IBAC Bulletin B01-4

Subject: Noise abatement take-off and climb procedures.

AMENDMENT NO. 11 TO PROCEDURES FOR AIR NAVIGATION SERVICES — AIRCRAFT OPERATIONS

Chapter 3

Figure 2. Noise abatement take-off climb — Example Distant procedure (NADP 2)

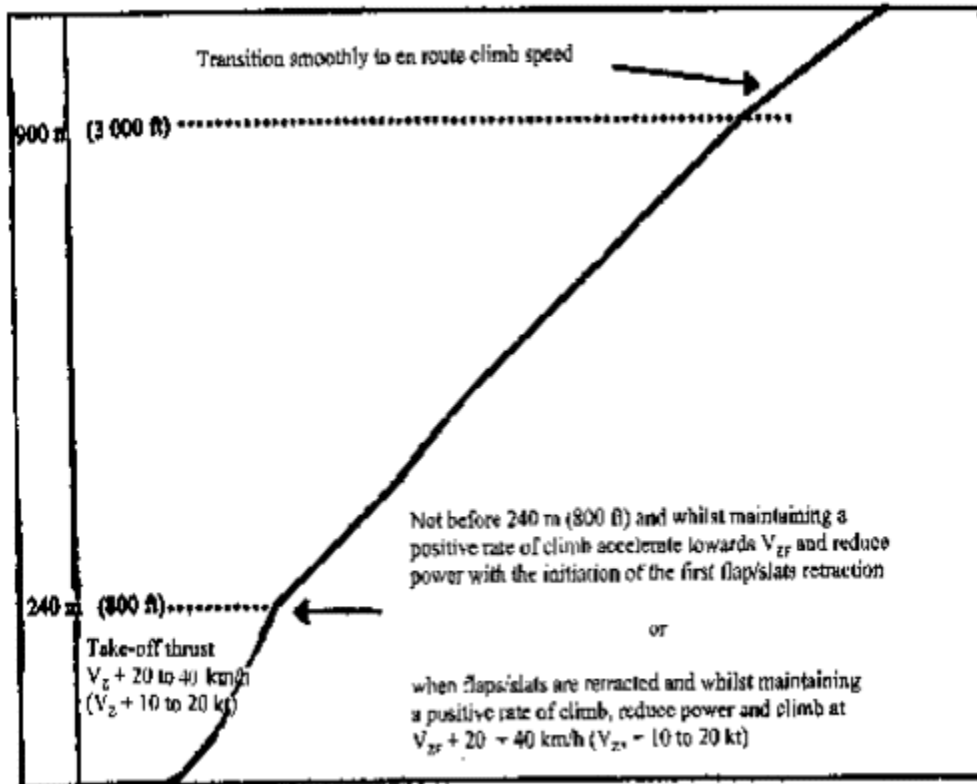
A.3.1 This procedure involves initiation of flap/slat retraction on reaching the minimum prescribed altitude. The flaps/slats are to be retracted on schedule while

maintaining a positive rate of climb. The power reduction is to be performed with the initiation of the first flap/slat retraction **or** when the zero flap/slat configuration is attained. At the prescribed altitude, complete the transition to normal en-route climb procedures.

A.3.2 The noise abatement procedure is not to be initiated at less than 240 m (800 ft) above aerodrome level.

A.3.3 The initial climbing speed to the noise abatement initiation point is V_2 plus 20 to 40 km/h (10 to 20 kt).

On reaching an altitude equivalent to at least 240 m (800 ft) above aerodrome level, decrease aircraft body angle/angle of pitch whilst maintaining a positive rate of climb, accelerate towards V_{ZF} and either:

- a) reduce power with the initiation of the first flaps/slats retraction; or
- b) reduce power after flaps/slats retraction.

Maintain a positive rate of climb and accelerate to and maintain a climb speed of $V_{ZF} + 20$ to 40 km/h (10 to 20 kt) to 900 m (3 000 ft) above aerodrome level.

On reaching 900 m (3 000 ft) above aerodrome level, transition to normal en-route climb speed.
